Report to Planning Committee 6 June 2024

Report Summary			
Application Number	23/01514/OUTM (Major)		
Proposal	Proposed residential development (9 units)		
Location	Former Allotments, Barnby Road, Newark		
Applicant	Mr Len Bateman	Agent	Guy Taylor Associates Architects
Web Link	23/01514/OUTM Proposed residential development (9 units). Former Allotments Barnby Road Newark On Trent (newark-sherwooddc.gov.uk)		
Registered	31.08.2023	Target Date	24.11.2023 Extension of Time Agreed 07.06.2024
Recommendation	Approve, subject to conditions and entering into a section 106 agreement

Images from Google streetview showing approximate position of site frontage in red (looking from west and east) and extent of visibility splay requiring removal/cutting back of hedge in yellow.

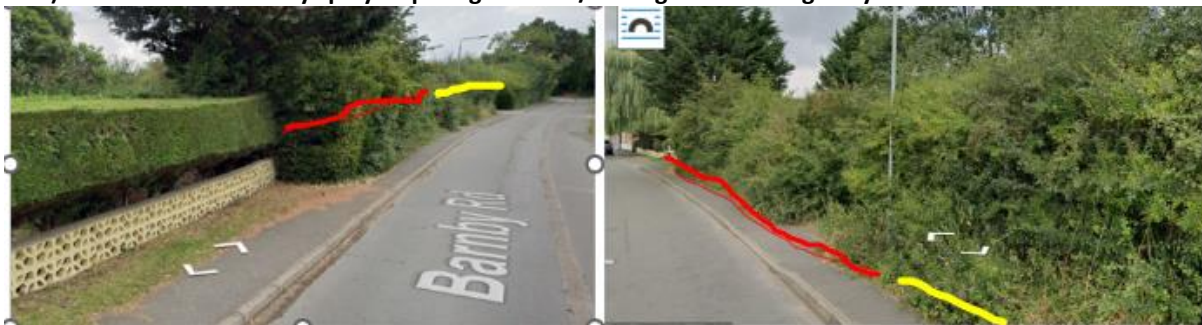
- 7.15 In addition to the removal of the hedgerow to create the new access, NCC Highways Authority initially pointed out the hedgerow in front of Ascot House (approximate position shown in yellow on above images) would have to be removed or significantly reduced in depth to provide for visibility splays. The agent has clarified through an ordnance survey plan (see para.7.47 and the image below it) that the hedgerow is likely to be able to remain but will need a trim.

- 7.16 Whilst the loss/reduction of this hedgerow is regrettable, the hedgerow is currently unmanaged and the visual appearance of the development (which would be primarily the new access road) would be softened by the greenery on either side of the access which would be kept undeveloped, whilst opening up views of the site from the public realm. There would be opportunities for additional, compensatory planting within the site. Overall, the changes to the character and appearance would be limited and are considered to be acceptable, subject to details of the built form being considered at reserved matters stage along with detailed landscaping which is also a reserved matter. The impact upon trees is discussed below at para. 7.22 onwards.

Trees

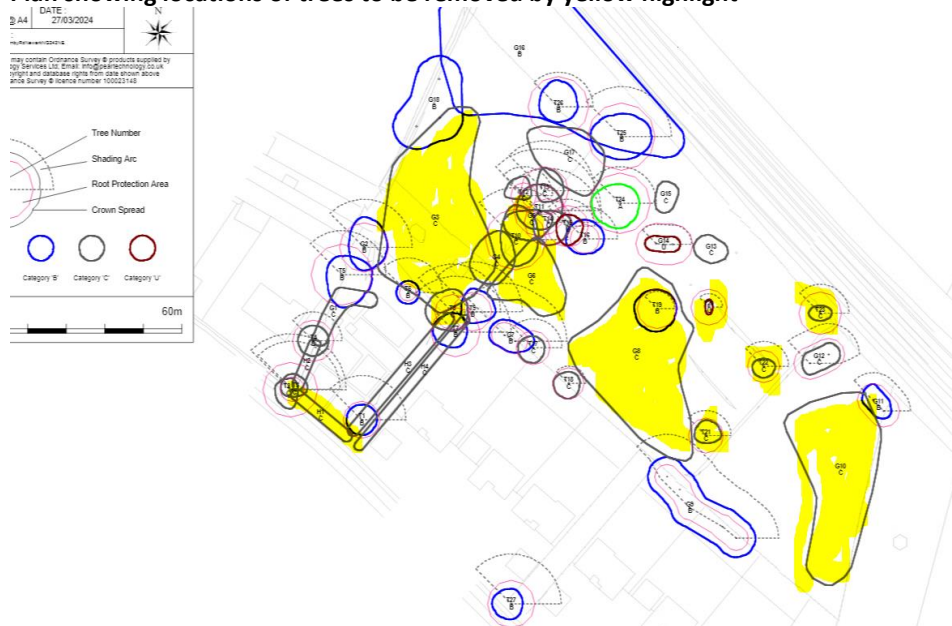
- 7.25 The Arboricultural Report surveyed 27 individual trees, 18 groups of trees and 4 hedgerows. Some of the trees on site form a significant part of the local treescape and give a moderate visual amenity value. These are primarily located to the site frontage visible from Barnby Road and those to the north of the site which are visible from the railway and land beyond.
- 7.26 This application would require the removal of:

8 individual trees; T8 & T10 (Common Ash, C1/2), T19 (Common Hazel, B1/2), T20 (Orchard Apple, U), T21, T22, T23 (Orchard Apple, C1)
